Date of Issue FEBRUARY 1951.

JAVELIN.

Item No.36. L.H.CRANKCASE - CONNECTING ROD CLEARANCE.

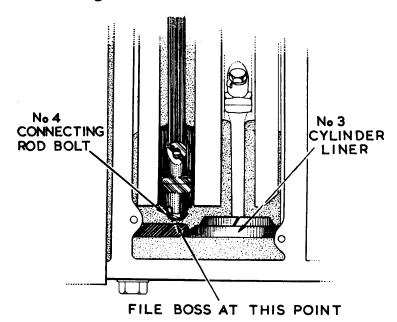
With the introduction of the new type connecting rod (Part No.54024) which is slightly larger in outside diameter than the type previously used (Part No.50650), a flat has been machined on the crankcase boss situated at the rear of number 3 cylinder base inside the left hand crankcase. This is to ensure that there is sufficient clearance between the crankcase boss and number 4 connecting rod bolt.

When fitting the new type connecting rods (Part No.54024) to vehicles prior to Engine No. EO/PB/10506 it is MOST IMPORTANT to ensure that there is adequate clearance between the
